Project: Nebraska Heart Hospital - Hybrid Operating Room Addition **3850**

Date: April 9, 2012
To: All bidders of record
From: Dan Mulligan, AIA

This addendum is hereby made a part of the contract documents to the same extent as though it were originally included therein. Revisions and clarifications to the drawings are referenced by the drawing number.

addendum no. 1

G000 Cover Sheet

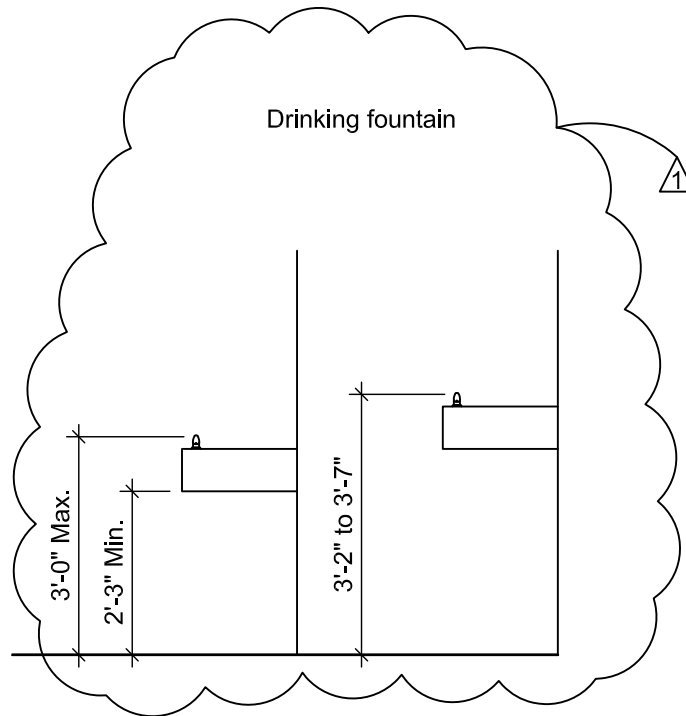
1. Revise mounting heights, drinking fountain.

A1 Wall Types
 A001 1" = 1'-0"

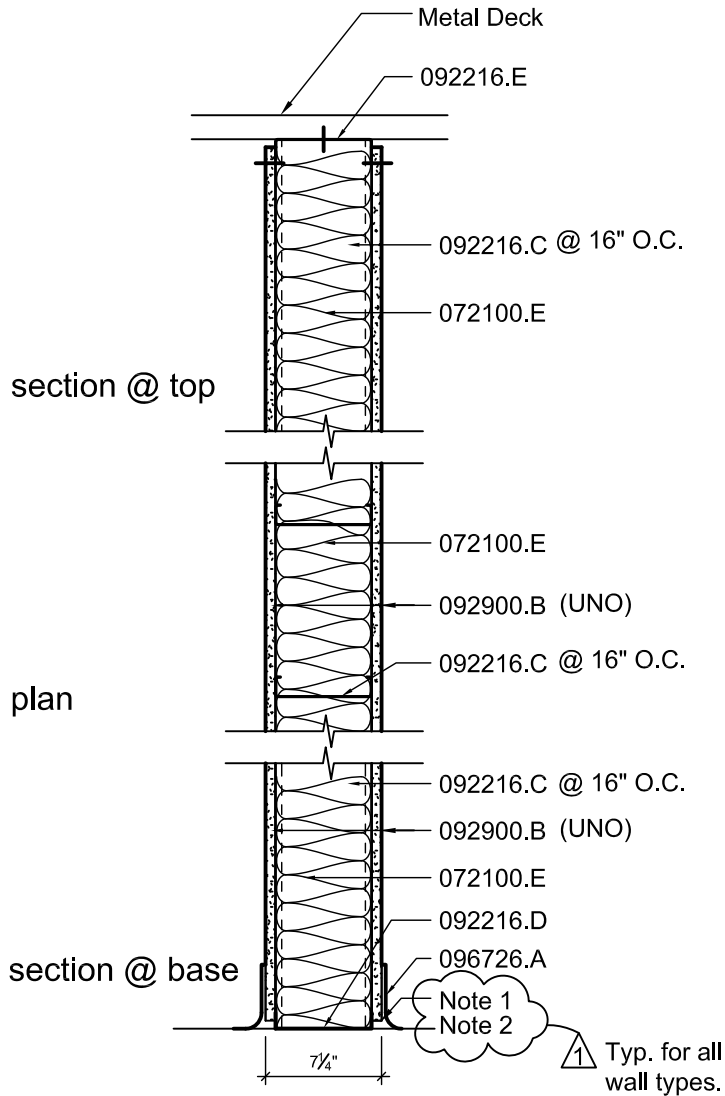
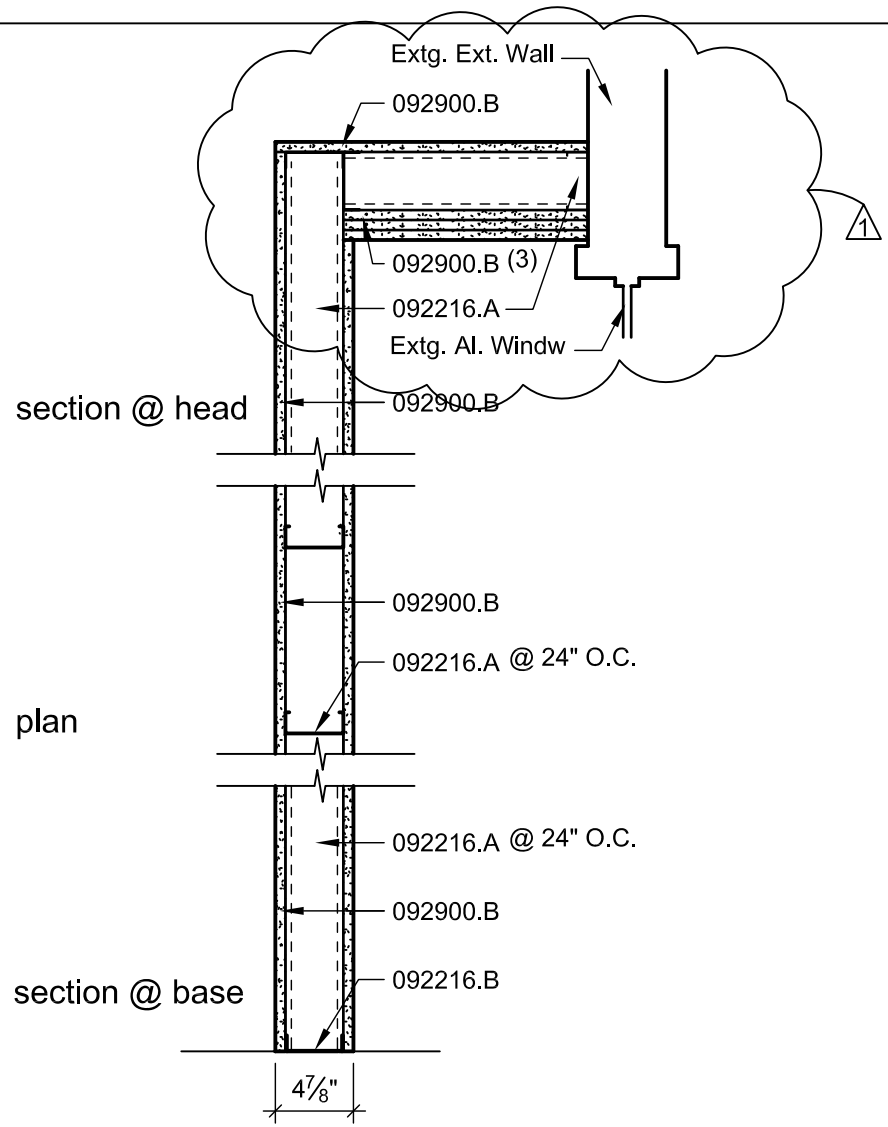
1. Architectural notes 1 and 2.
2. Wall Type 1, additional layers of 5/8 GB underside of horizontal return.

NOTE 1 PROVIDE 1/2" CLEARANCE BETWEEN TOP OF CONCRETE SLAB AND EDGE OF WALL BOARD.

NOTE 2 ACCOUSTICAL SEALANT, BOTH SIDES OF METAL RUNNER CHANNEL.

Framing Plan

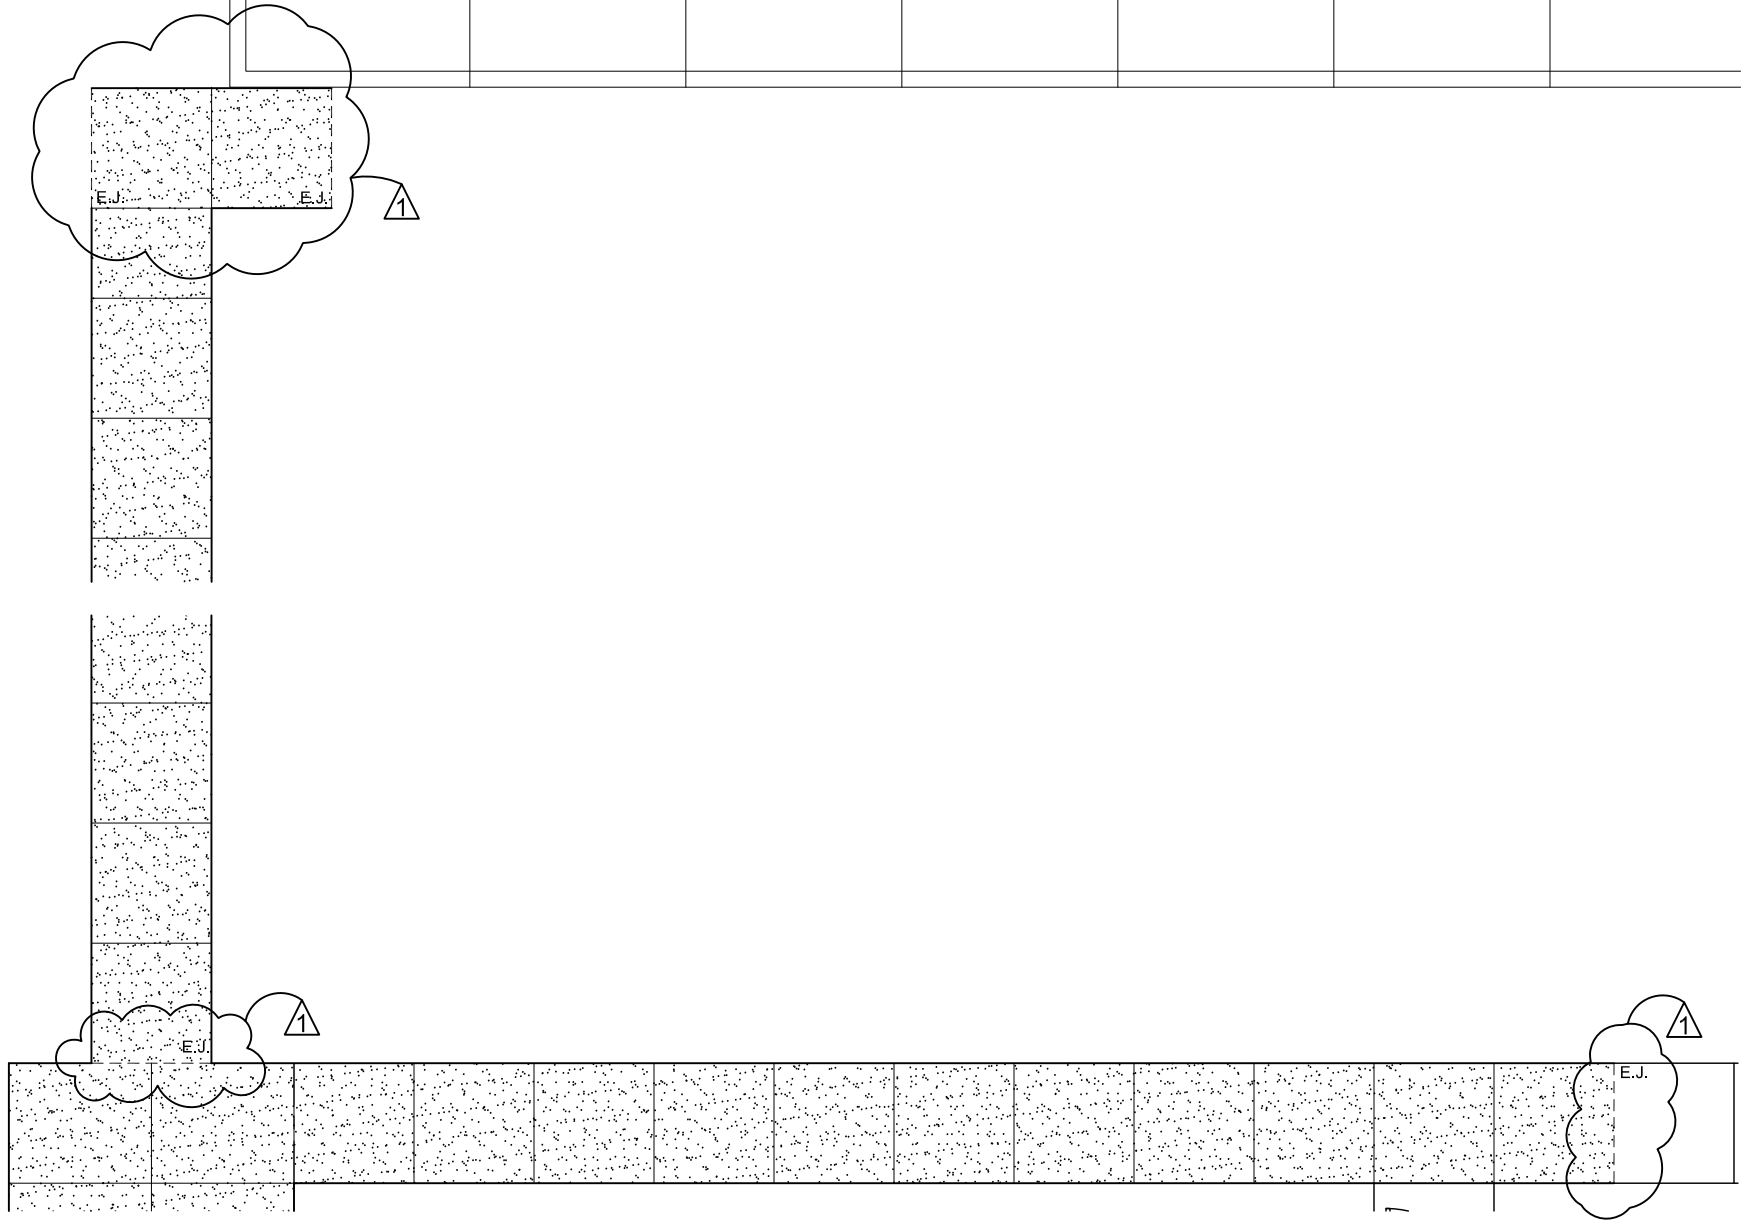
1. Indicate expansion joint locations, new sidewalk.

A8 Parapet Detail
 A115 1" = 1'-0"

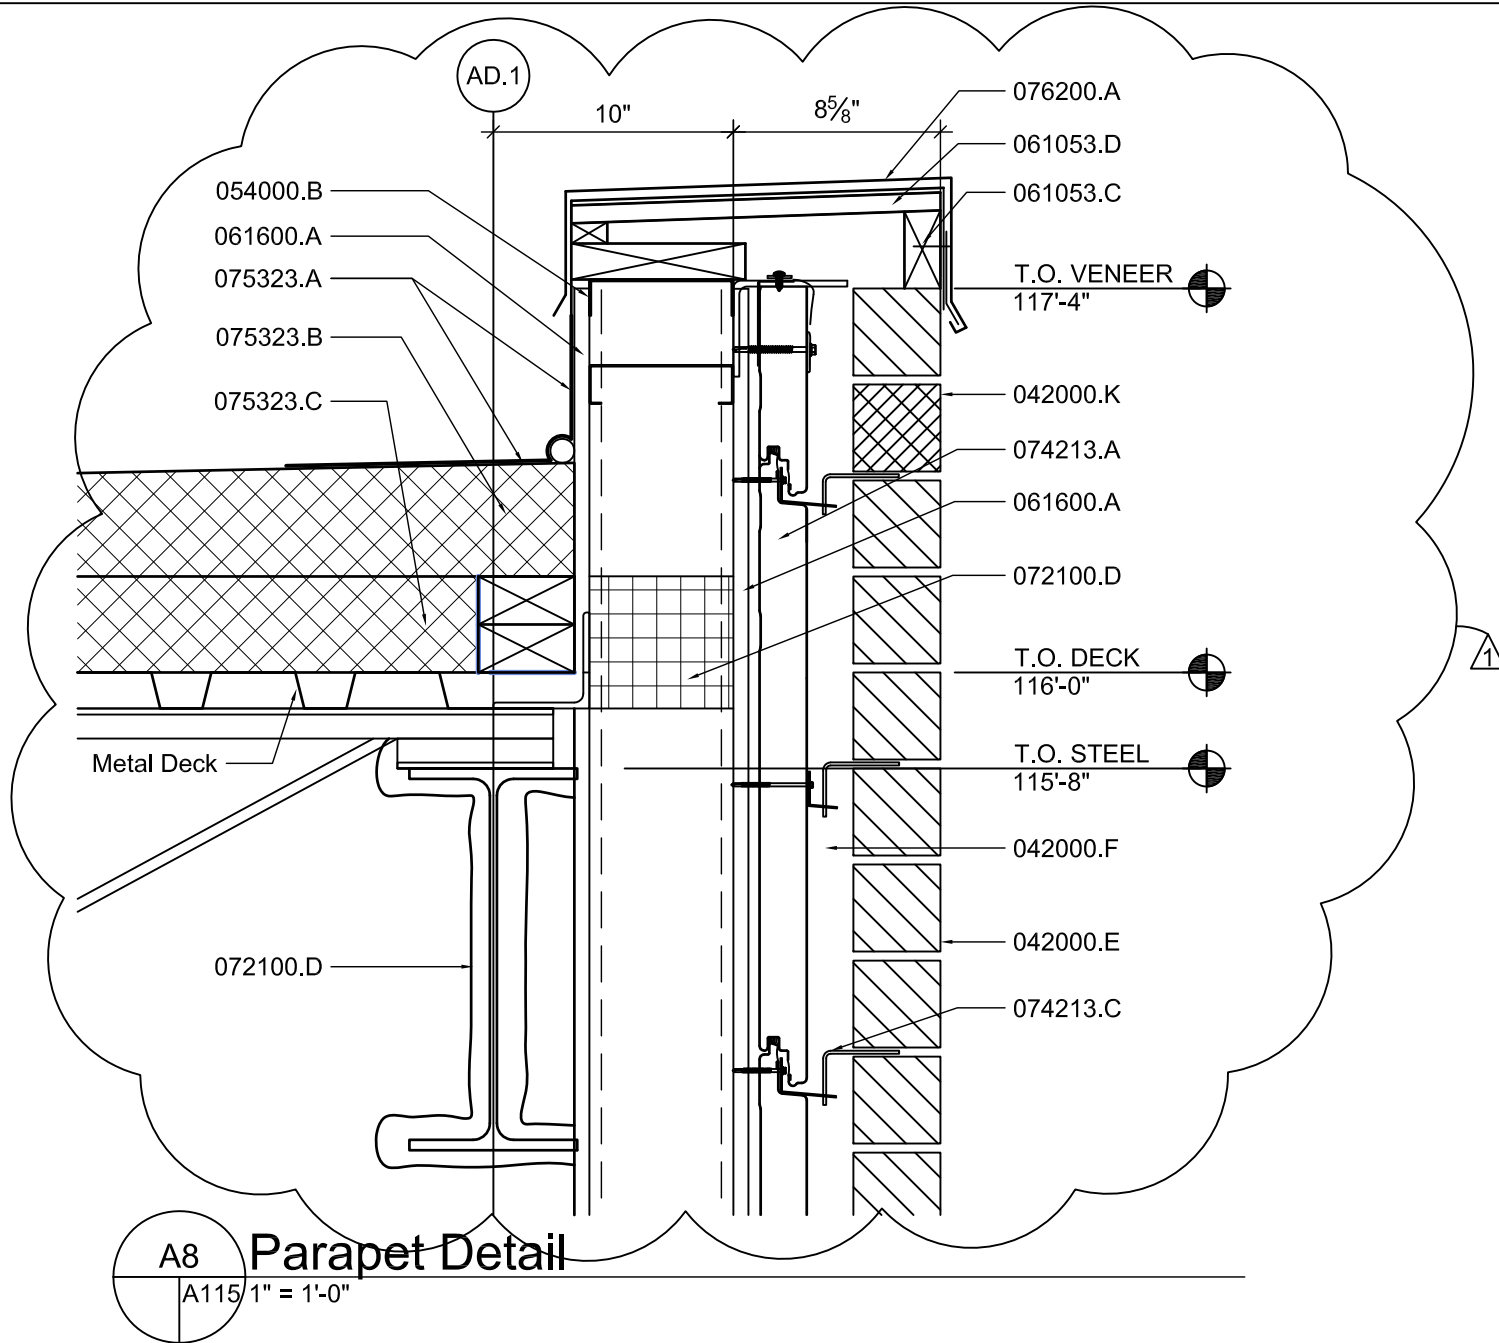
1. A8 - Parapet Detail: revise metal parapet flashing connection.
2. A12 - Parapet Detail: additional dimension.

D1 Operating Room 100, South
A100 3/8" = 1'-0"

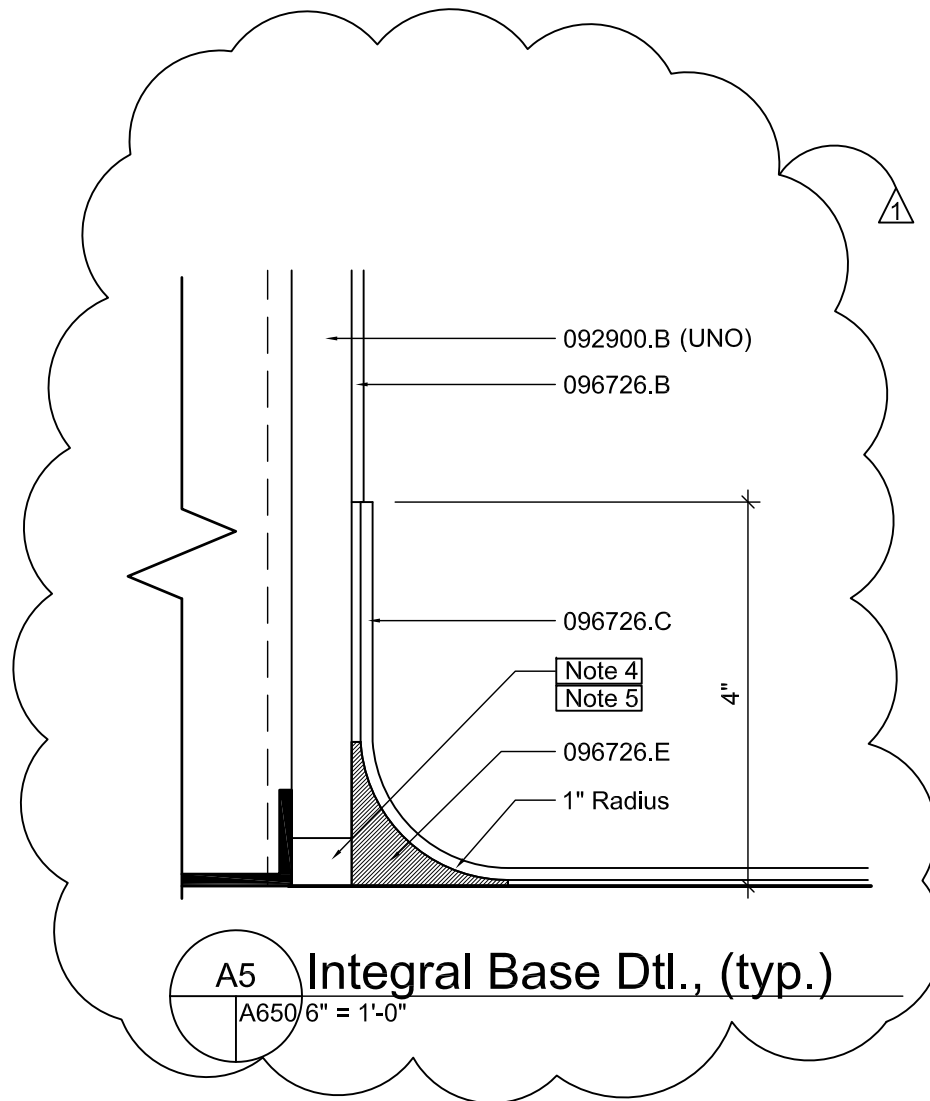
1. D1 - Operating Room 100, South: clarify mounting height dimension, fire extinguisher cabinet.

A5 Integral Base Dtl., (typ.)
 A650/6" = 1'-0"

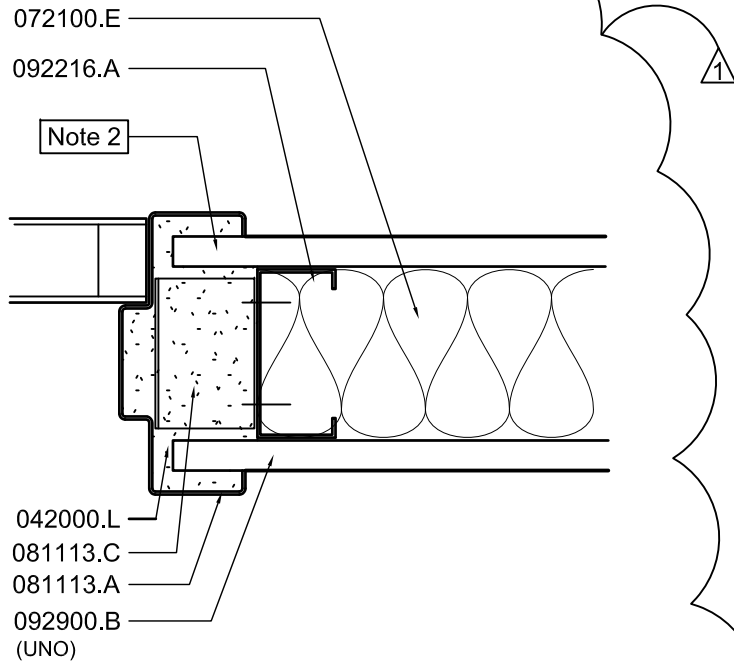
1. A5 - Integral Base Detail (typ.): Revise.
2. A12 - Interior HM Door Jamb: Extend GWB into frame.
3. Architectural Notes 2-5.

- Note 1** Connection box by others, shown for location only.
- Note 2** At radiation doors, position GWB as deep as possible into the hollow metal frame.
- Note 3** Not Used
- Note 4** Provide 1/2" clearance between top of concrete slab and edge of wall board.
- Note 5** Acoustical sealant, both sides of metal runner channel.
